March 4, 1983

Subject: Limerick Generating Station, Units 1 & 2
Request for Additional Information (RAI)
from NRC Instrumentation and Control
Systems Branch

Transmitted herewith are draft responses and FSAR page changes related to the subject RAIs. This material is provided in draft form at the request of Mr. Virgilio, NRC staff reviewer, in advance of a meeting the week of March 14, 1983. We plan to formally incorporate these responses and page changes into the FSAR subsequent to the March 14 meeting.

REACTOR PROTECTION SYSTEMS
NUCLEAR POWER SYSTEMS PART 1

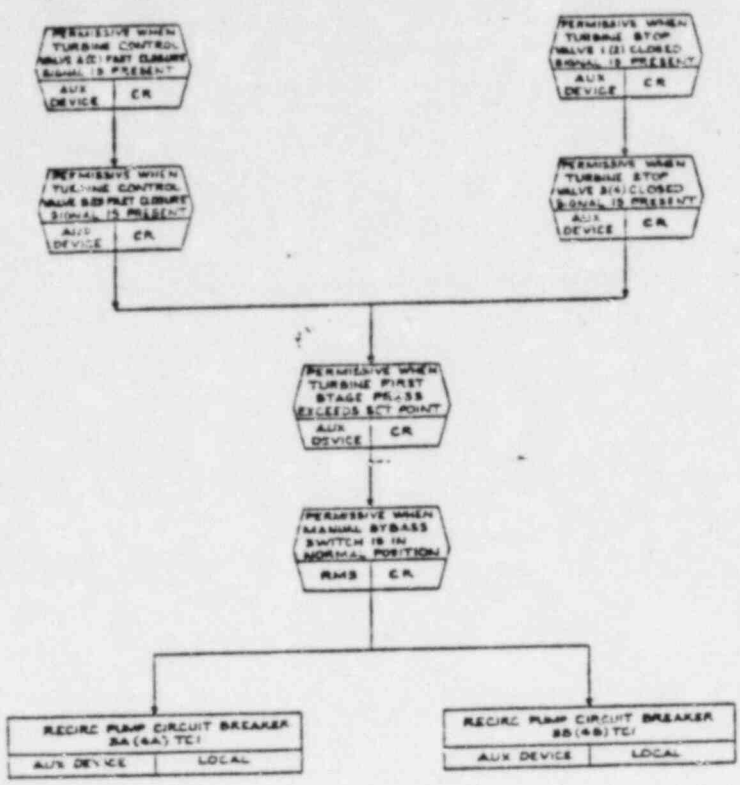
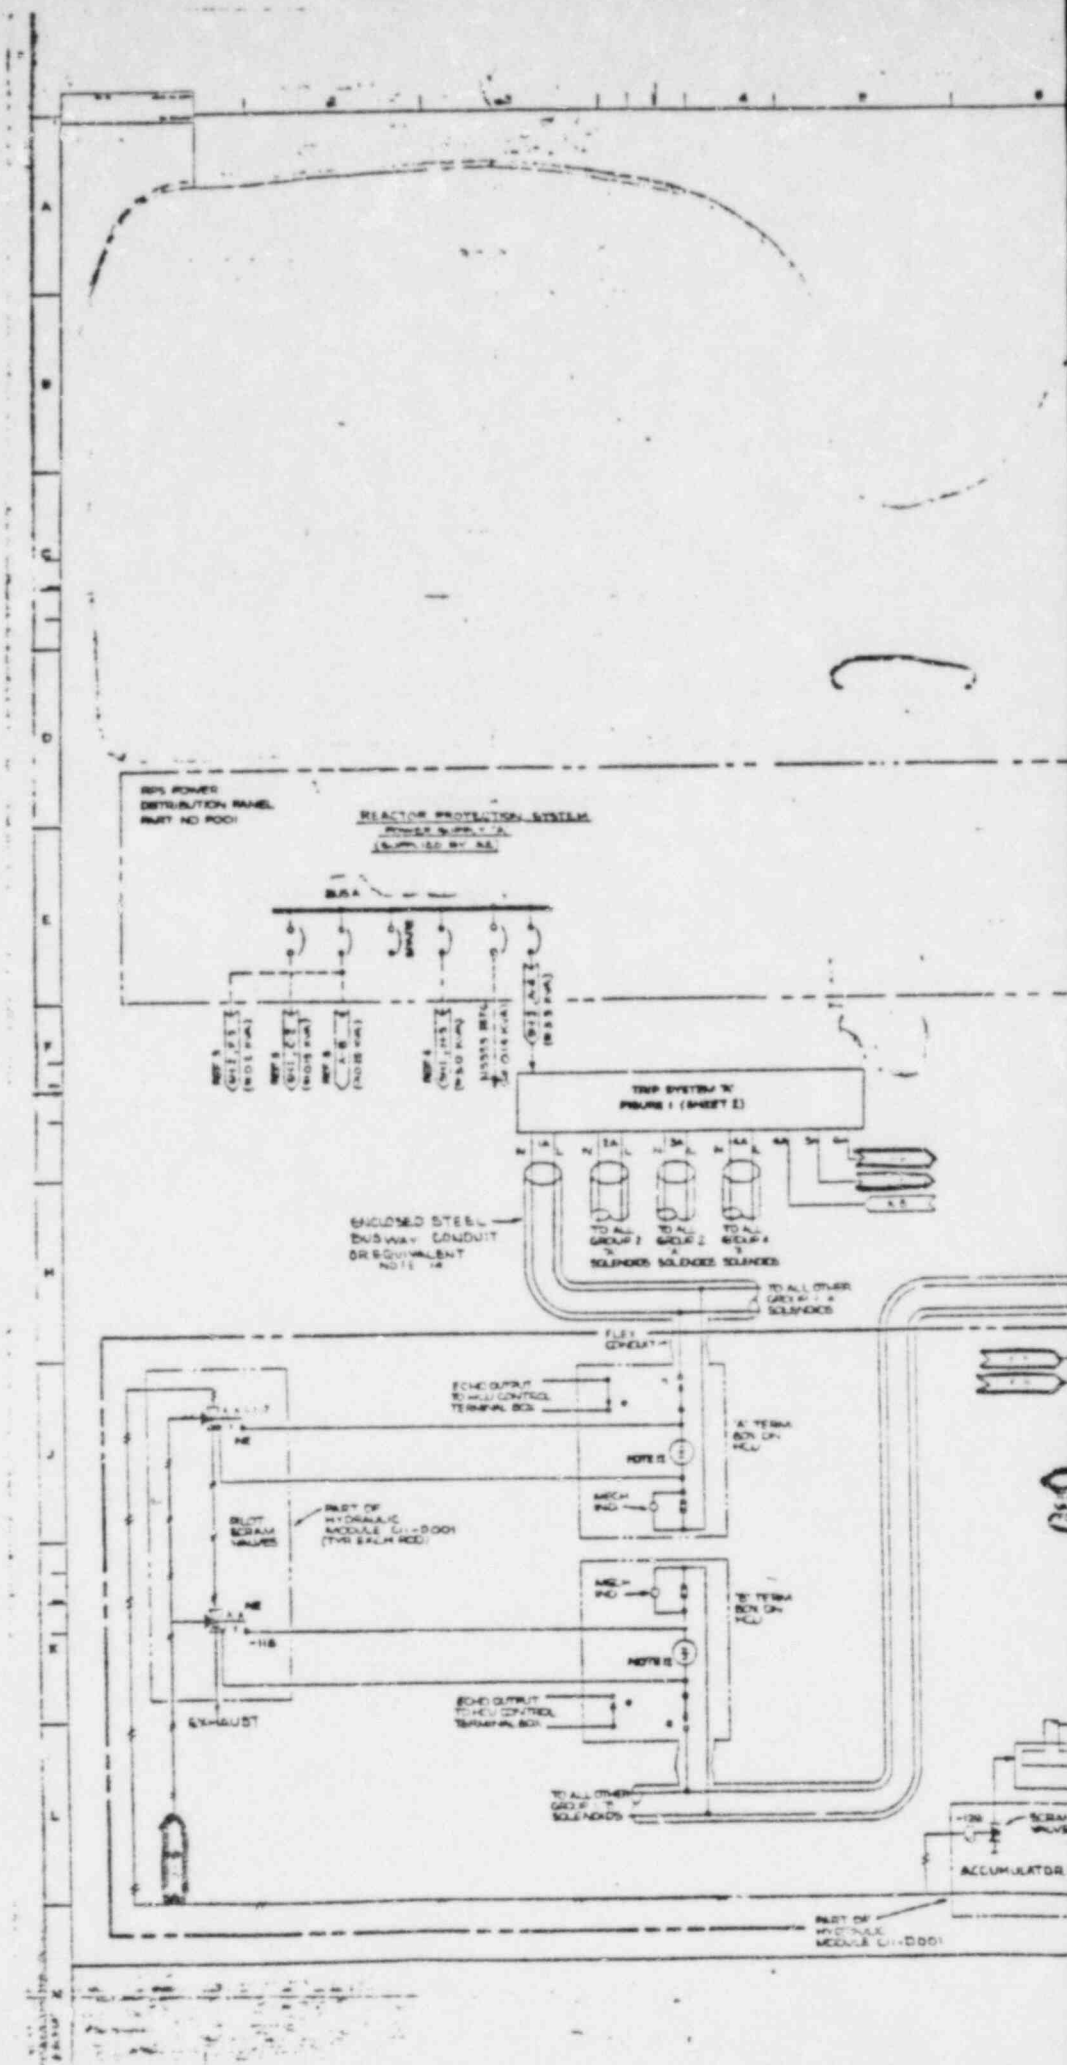
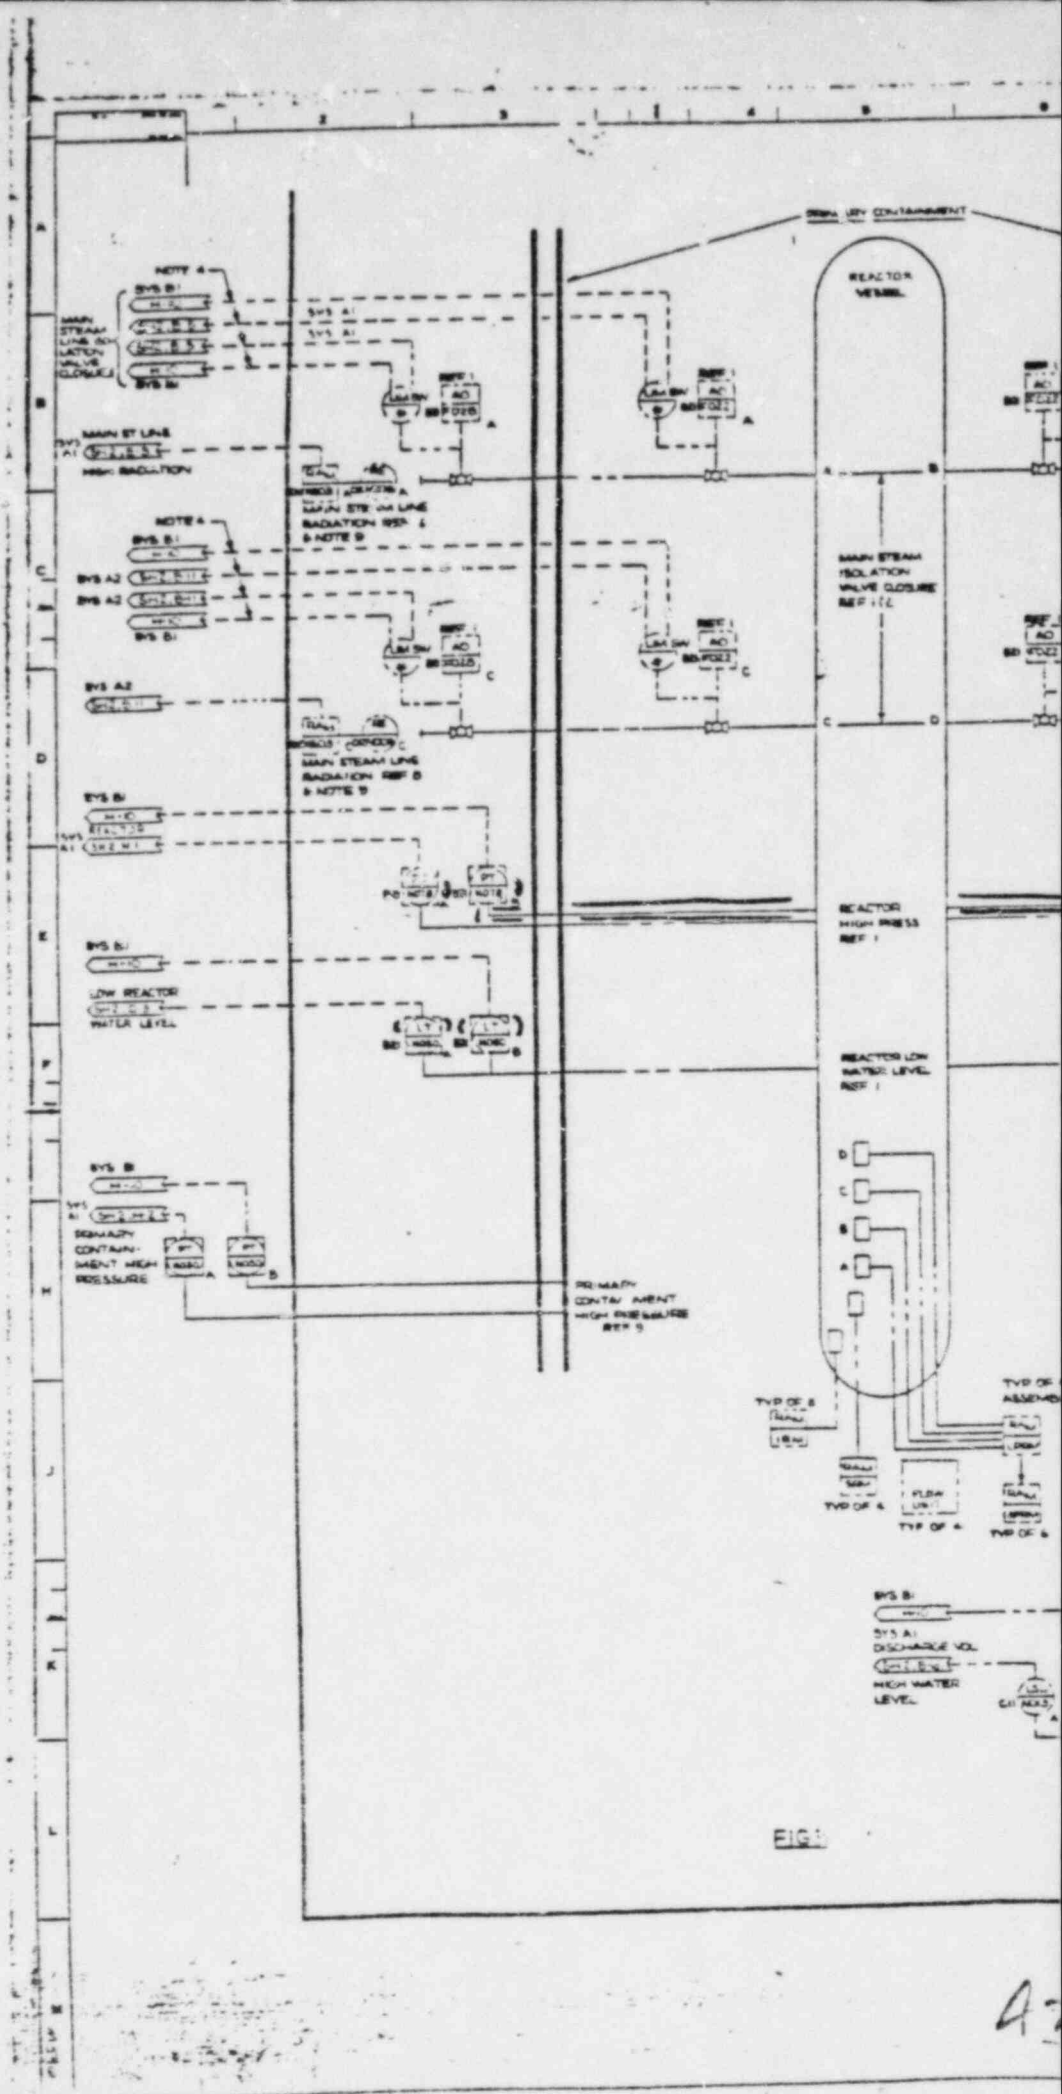
Section 7.2.1.1.4.7 of the FSAR indicates that pilot solenoids for the scram valves "not part of the RPS" and that the RPS interfaces with the p. solenoids. Discuss the interface area using detailed schematics and drawings as appropriate. Include in the discussion the backup scram valves, their classification and their interaction or interface with the RPS.

The pilot solenoids for the scram valves are part of the hydraulic control unit (C11-D001) of the associated control rod in the control rod drive system.

The function of the pilot scram valve solenoids and the backup scram valves, and their interface with the RPS, are discussed in Sections 7.2.1.1.4.7 and 7.2.1.1.4.8, and detailed in Figure 7.2.1 (sheet 1).

FIGURE 7.7-14

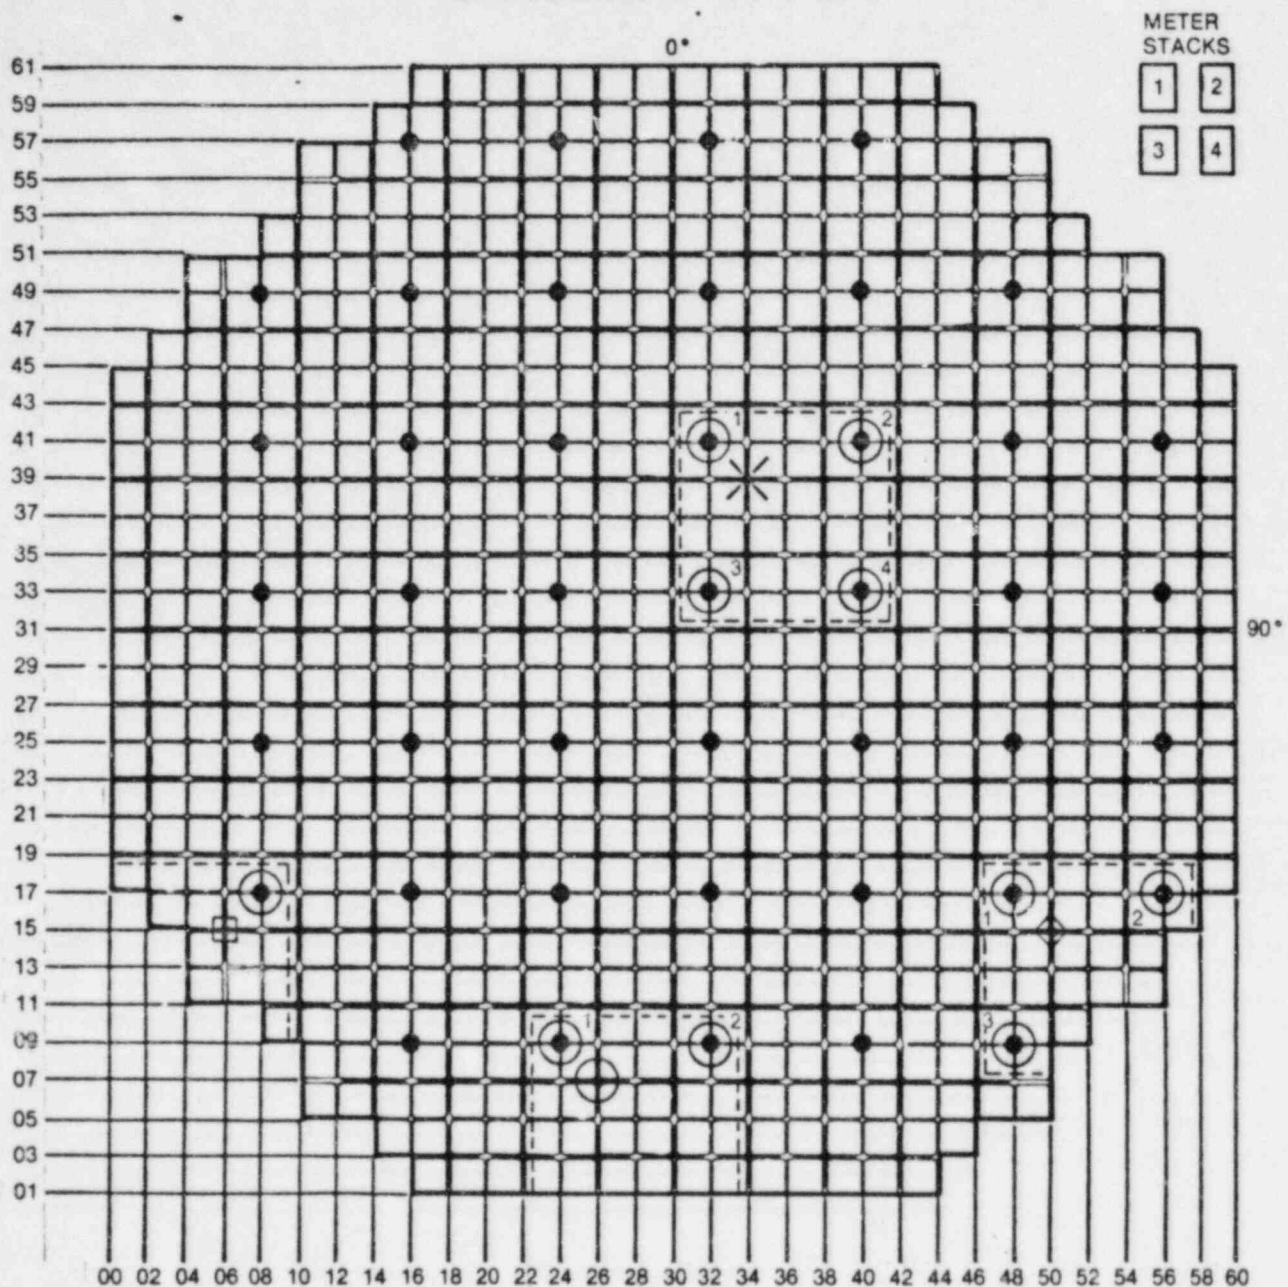
Figure 7.7-14 of the FSAR which provides details of the RBM circuit is not included. It is indicated the information will be provided later. Discuss the status of your design of the RBM and projected availability of Figure 7.7-14.

Figure 7.7-14 showing the RBM rod selection combinations has been added. Section 7.7.1.6.2.1 has been changed to reference the appropriate figure.

LIMERICK GENERATING STATION UNITS 1 AND 2 FINAL SAFETY ANALYSIS REPORT
AUTOMATIC INITIATION LOGIC-HPCI
FIGURE 7.3-5

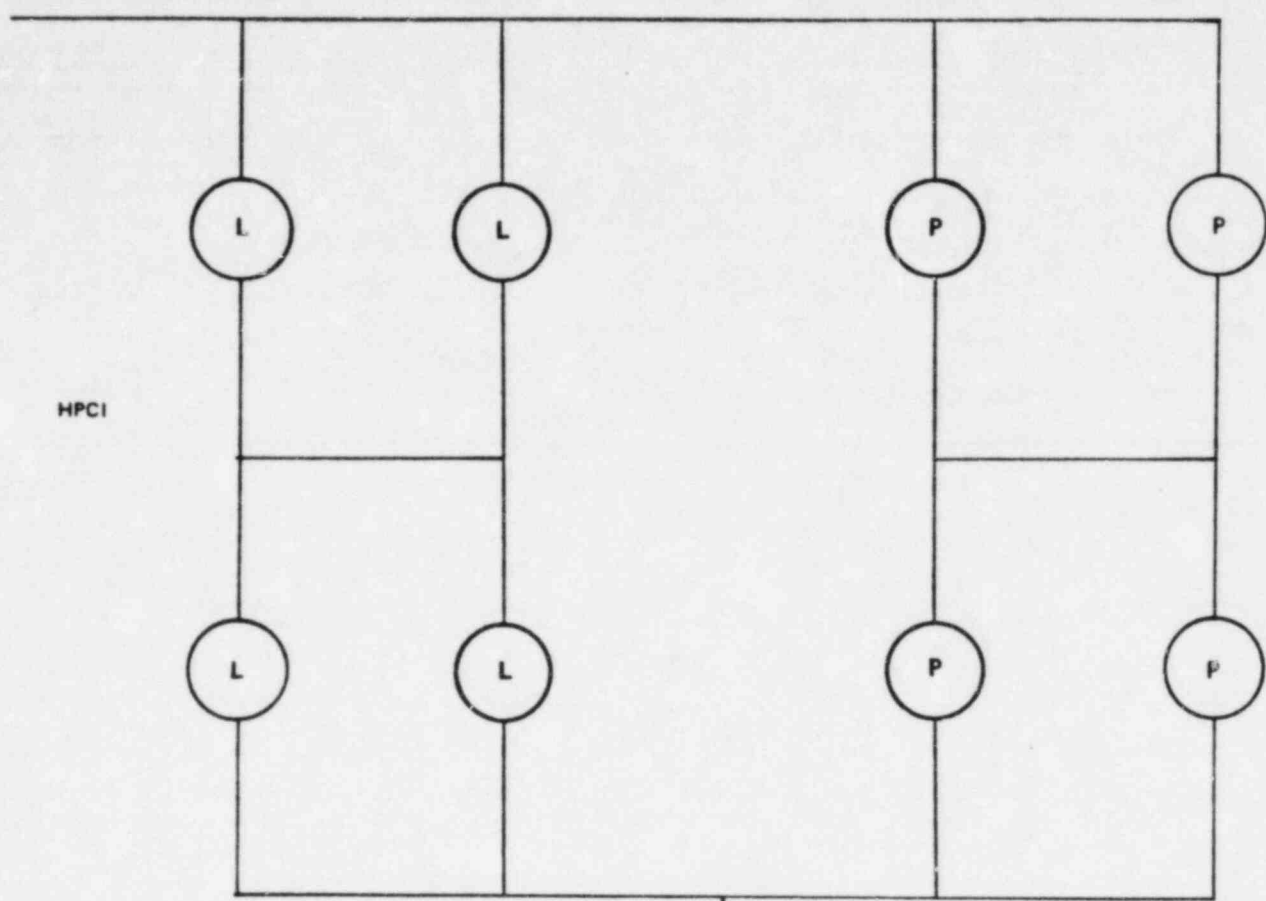
There appears to be a discrepancy between the number of instrumentation channels as described in Section 7.3.1.1.1.1.3 and the logic shown in Figure 7.3-7. Also the logic shown in Figure 7.3-5 does not agree with the logic in Figure 7.3-7 or the logic described in Section 7.3.1.1.1.1.4. Describe the as-built system and correct apparent discrepancies.

Figure 7.3-5 and Section 7.3.1.1.1.1.3 have been changed to correct the discrepancies. A revised Figure 7.3-7 will be provided by June 1983. There are four level transmitters and four drywell pressure transmitters incorporated in the HPCI initiation circuitry. The four trip units that operate off the level transmitters are combined in a one-out-of-two-twice logic for automatic system initiation. The same is true for the drywell pressure transmitter/trip units. Either of the two logic trains will initiate the system. The turbine trip logic for high water level is also one-out-of-two-twice and not two-out-of-two as stated in the text. Section 7.3.1.1.1.4 is correct in its description of the initiation logics.

FIGURE 7.3.4

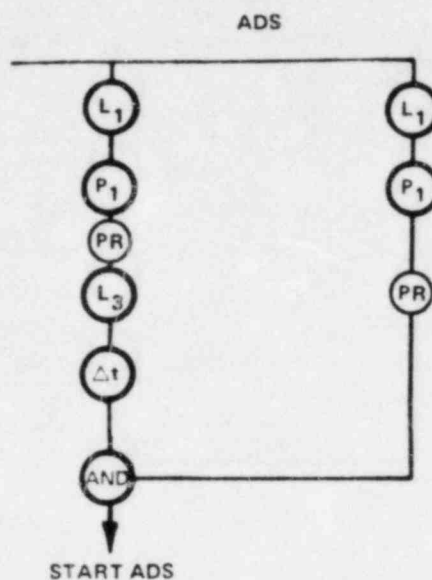
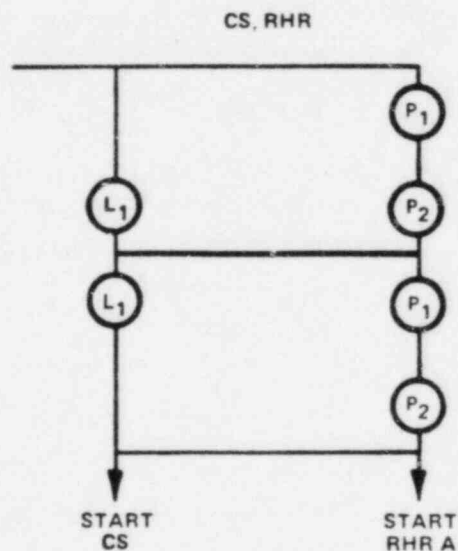
The description of the initiation logic for the ADS includes a permissive interlock from the LPCI or the CS pumps running signal. This permissive, however, is not shown on Figure 7.3-4. Correct the apparent discrepancy.

Figure 7.3-4 has been revised to agree with the description of the initiation logic for the ADS.
